INTEGRATED WATER MANAGEMENT PLAN

250415 - LANE COVE NORTH SOCIAL AND AFFORDABLE HOUSING

Project Number: 250415
Project Name: Lane Cove North Social and Affordable Housing
Prepared For: Link Wentworth
Date Prepared: 16.04.2026
XK Project Director: Duncan Marshall

Status	Issue	Date	Prepared By	Approved By
For S4.55 Approval	1	16.04.2026	Evan Legg	Duncan Marshall

Sheet Subject
CIVIL WORKS PLAN

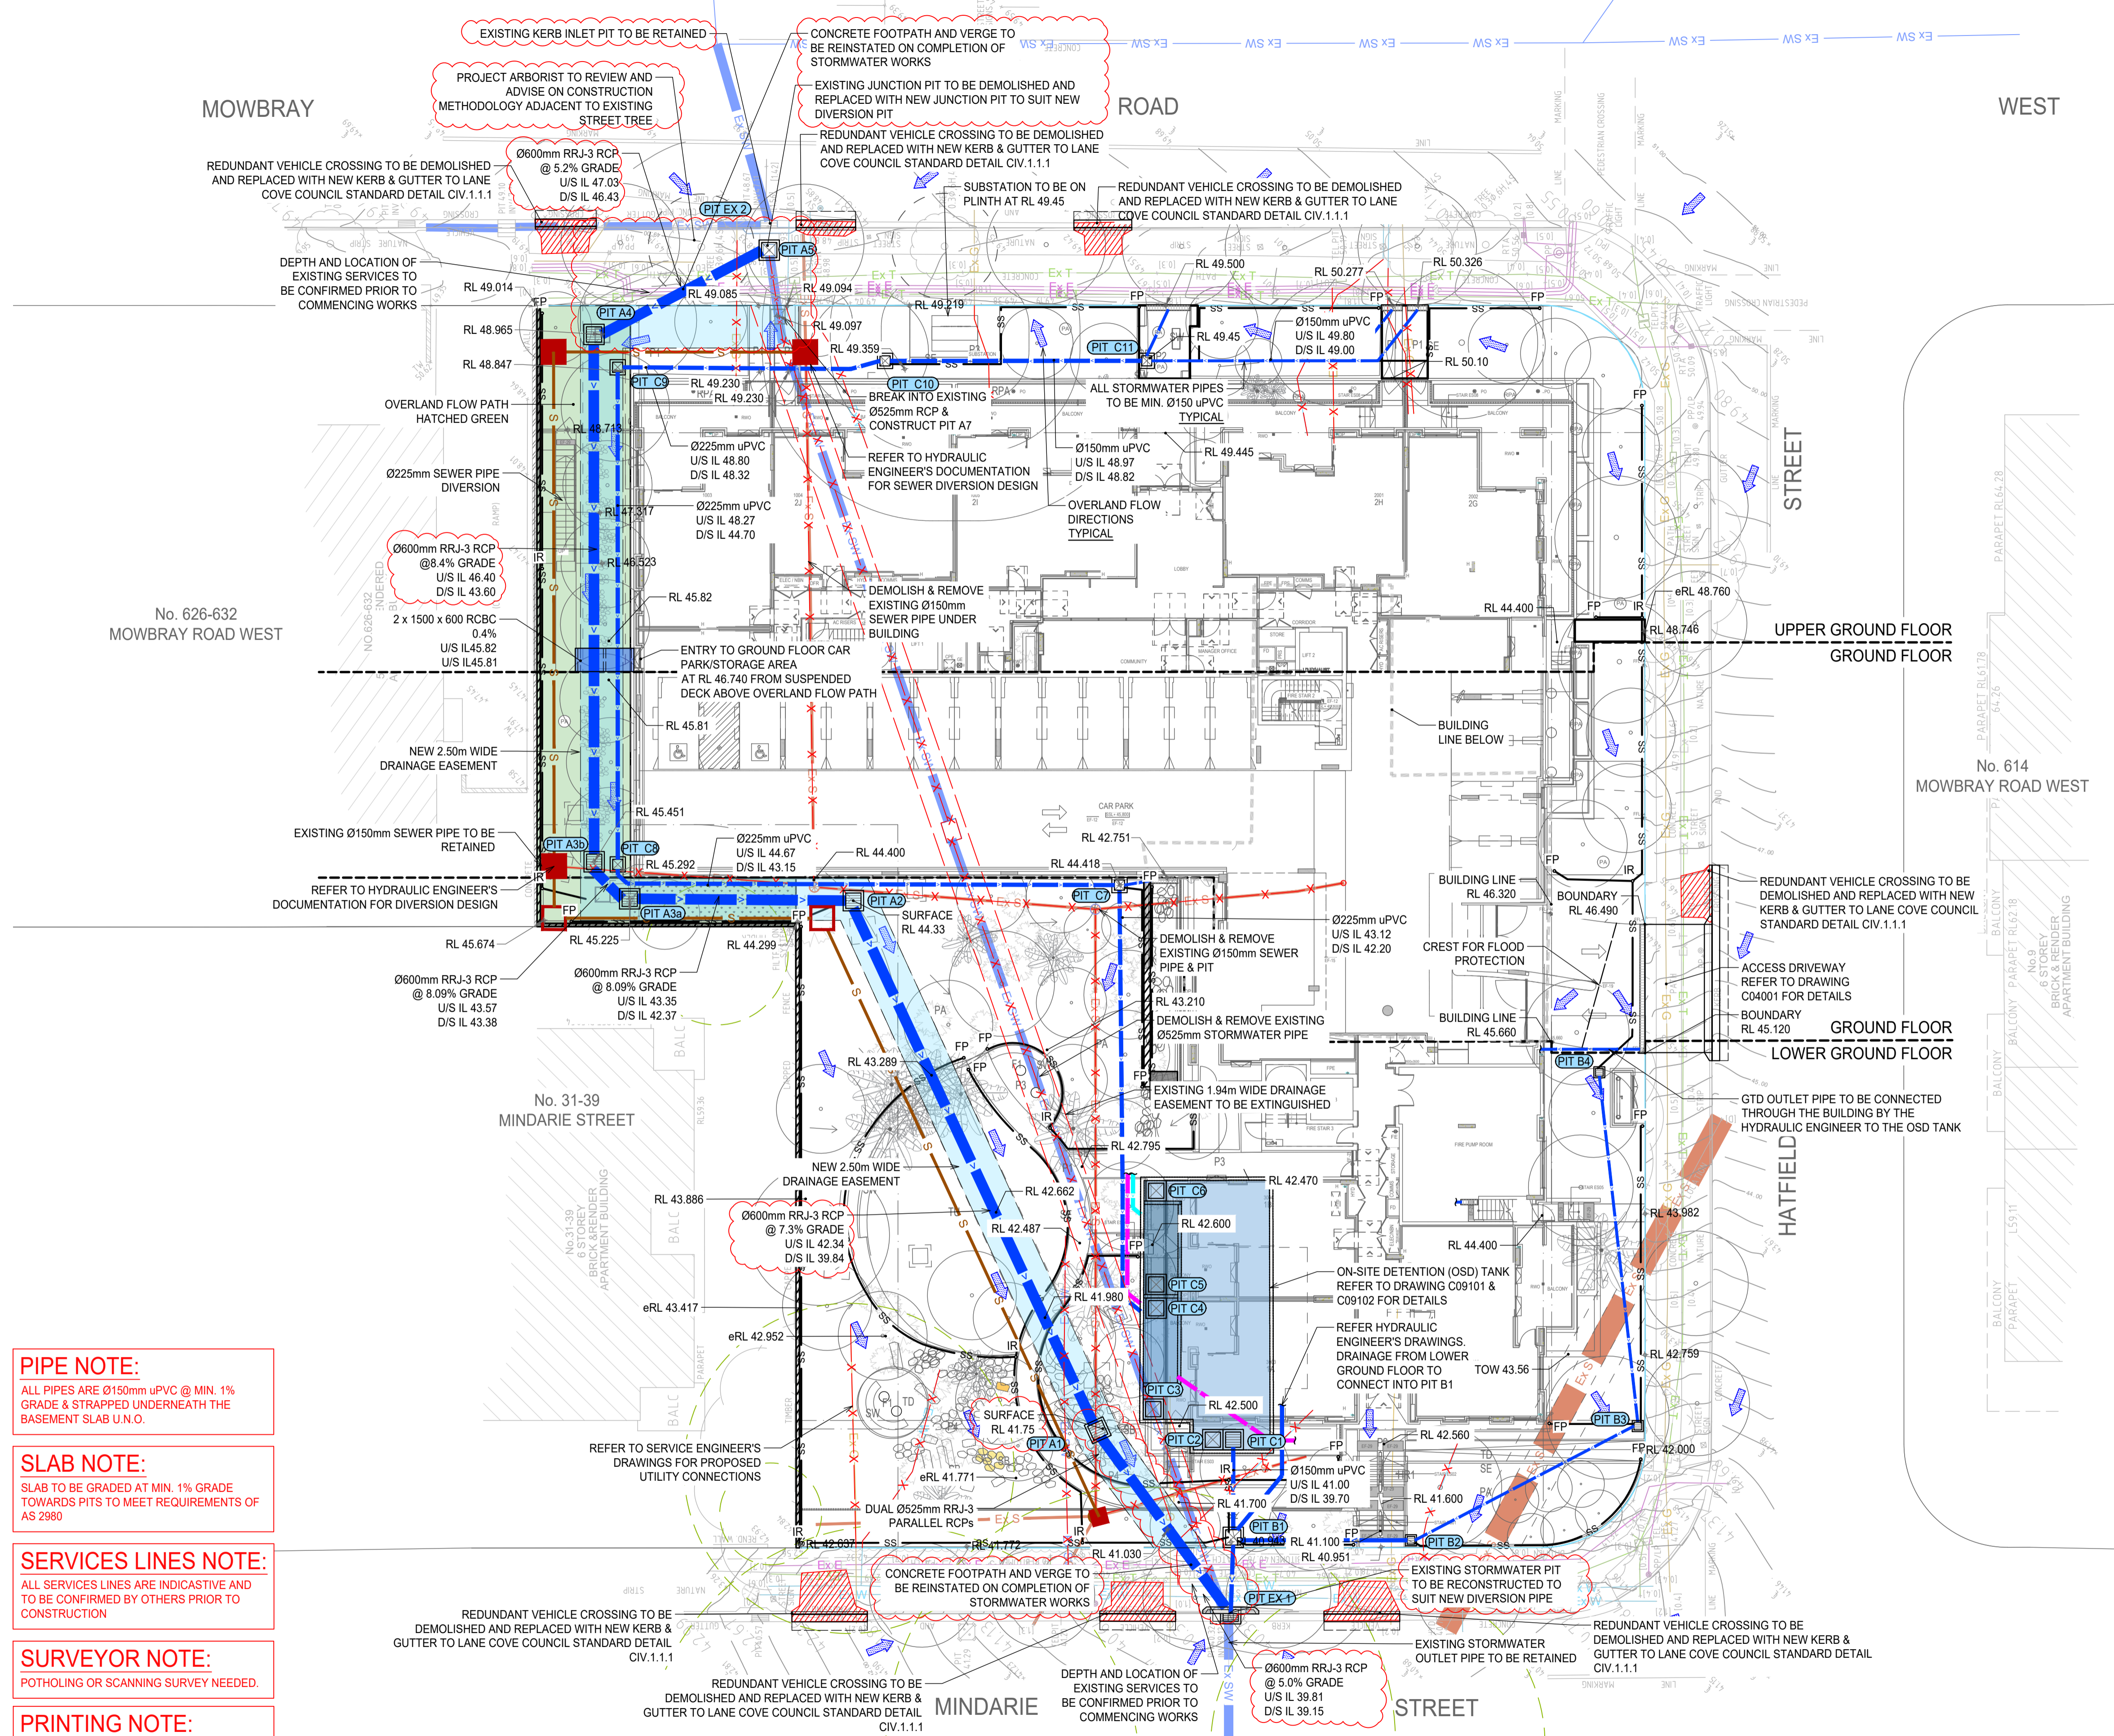
Thank you for sending Drains file and updated plan for drainage relocation through 618-624 Mowbray Rd west and 25-29 Mindarie St, Lane Cove North.

The stormwater drainage diversion plan prepared by Xavier Knight, reference Number: 250415, revision: 7 and dated 19/01/26 is satisfactory.

Council wants to start this pipe diversion from this closed junction pit as marked in photos. This is clearly shown in the markup (black line) plan attached below.

- Based on the as-built plans and markup provided by Council, we have adjusted this connection to instead provide a 600mm RCP pipe from the existing junction pit in the street to Pit A5 within our site. We are proposing to reconstruct the existing Junction Pit behind the kerb inlet pit to allow for the new 600mm pipe.
- These works will also involve reinstatement of the footpath pavement and verge

PROPOSED STORMWATER DIVERSION - LONGITUDINAL SECTION
SCALE H1:200, V1:100

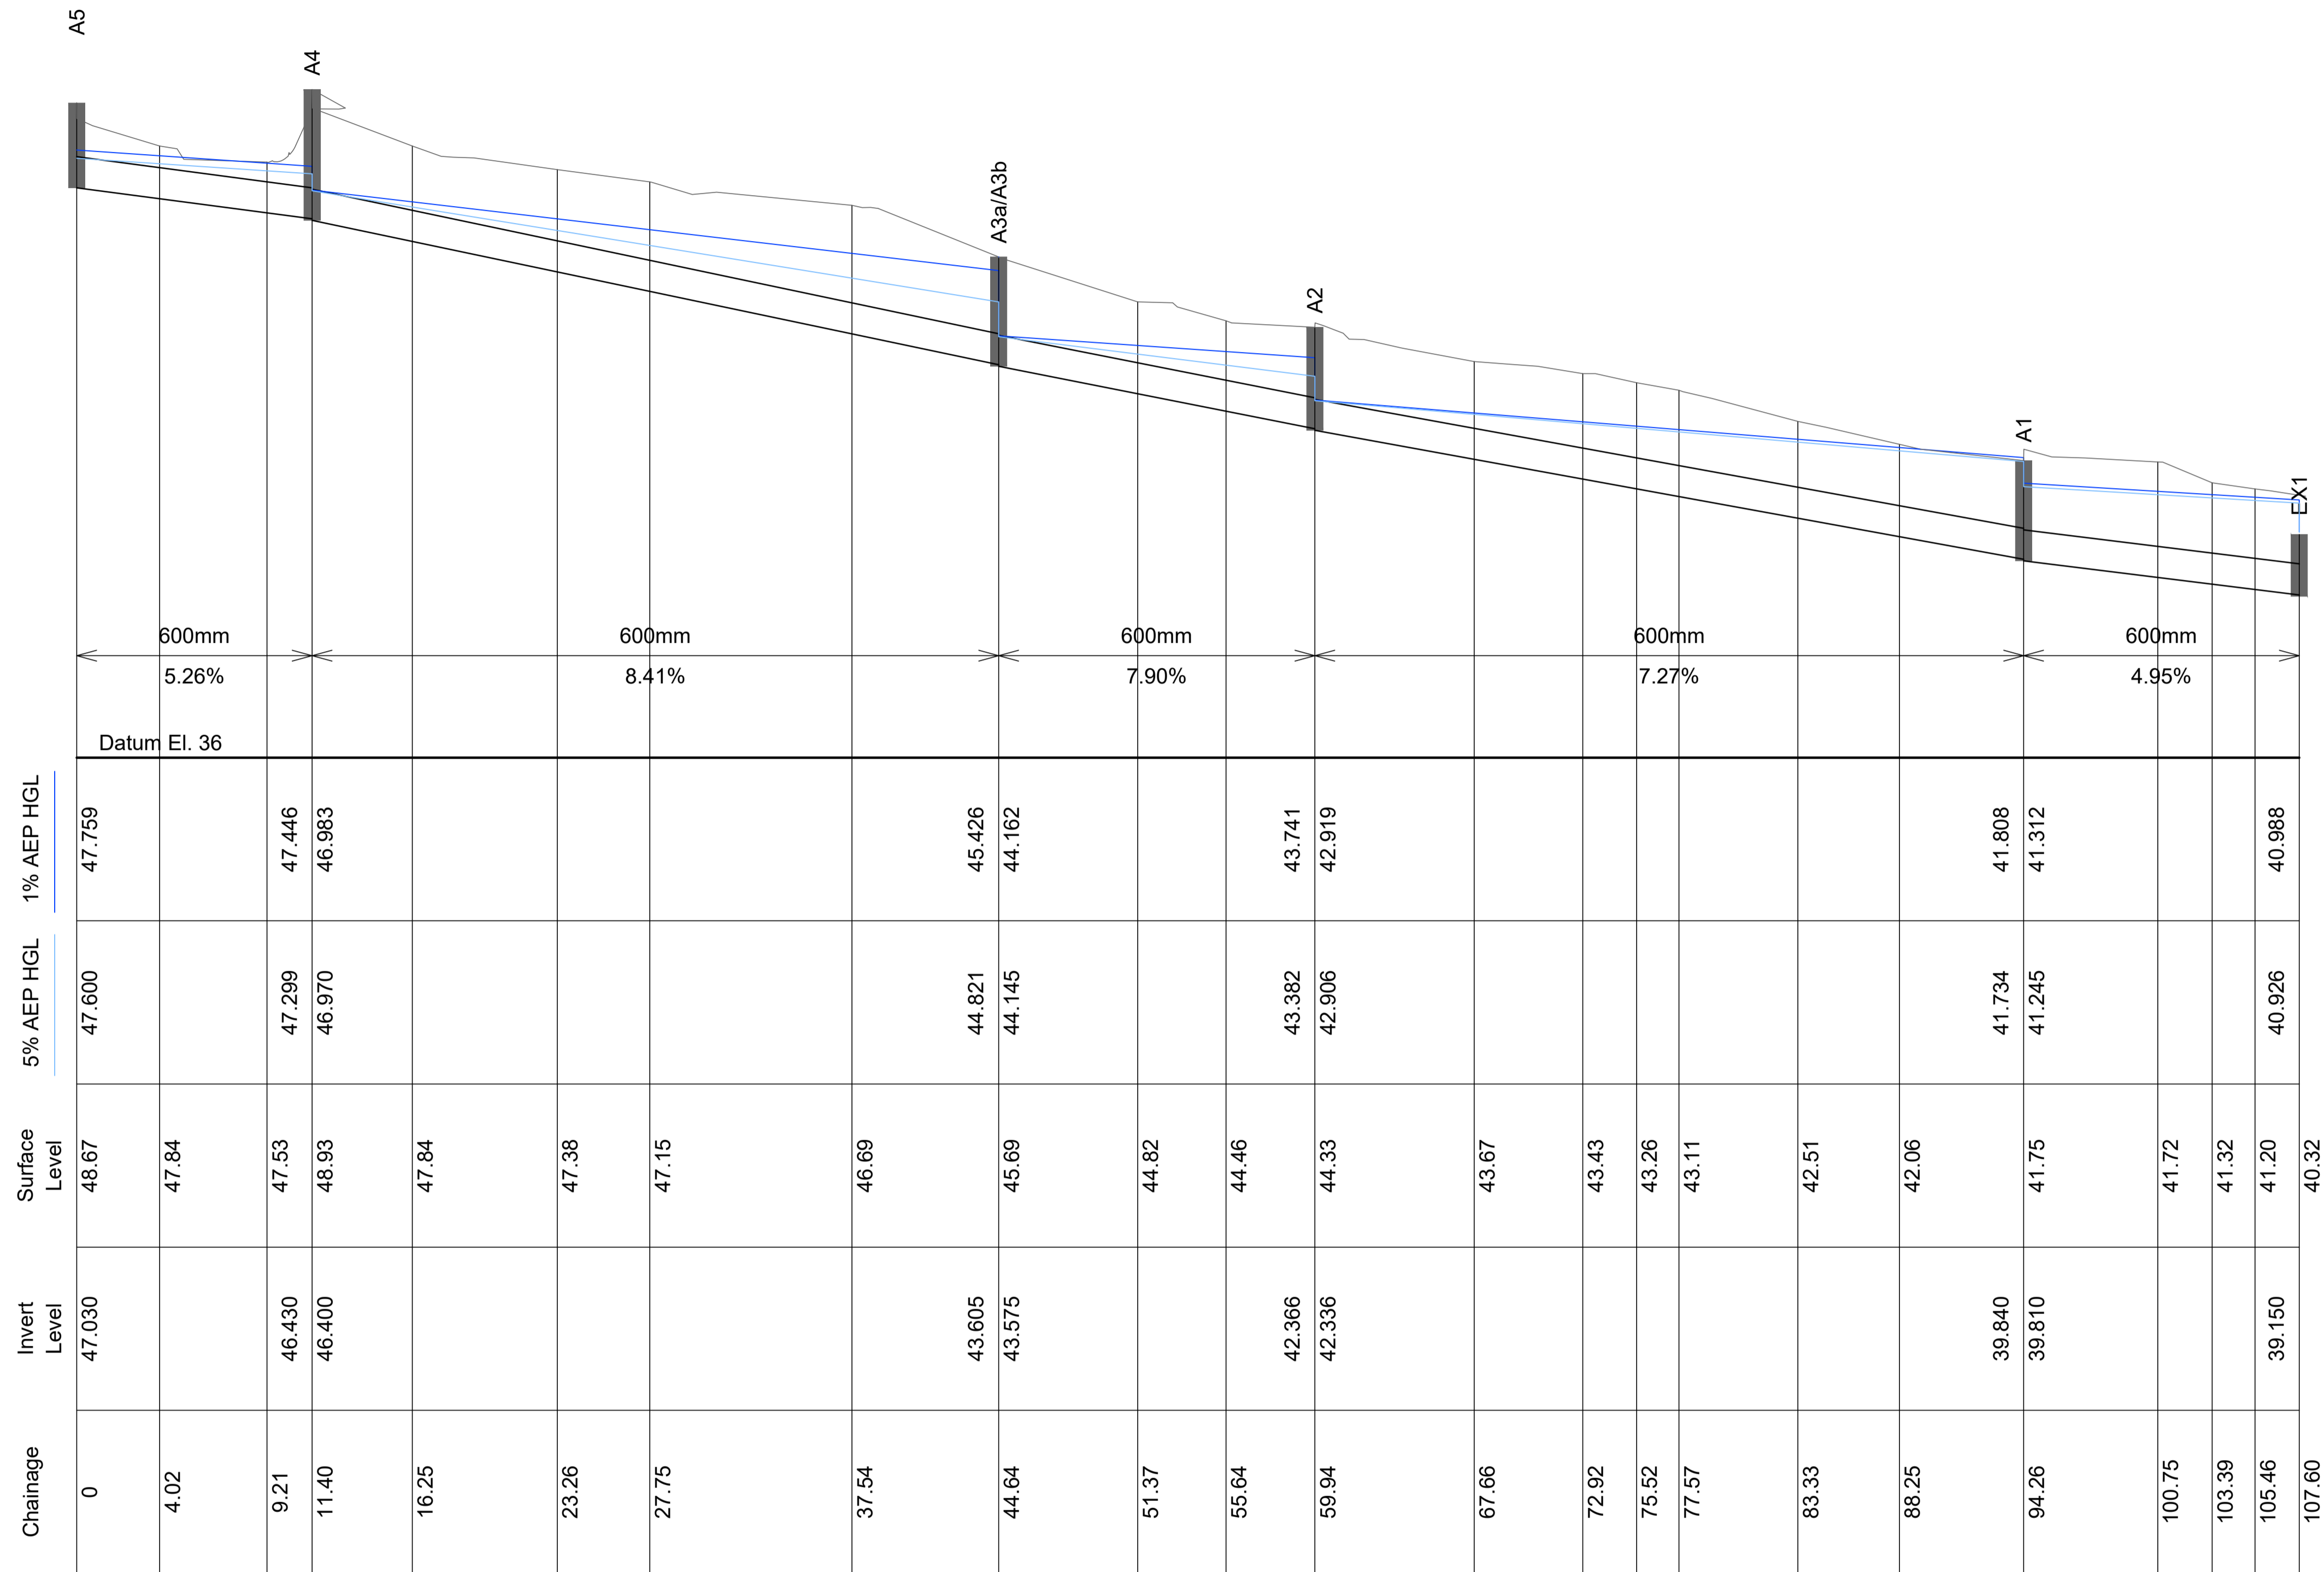
Please find attached updated Stormwater Diversion Plan and Longitudinal Sections for Council Approval.
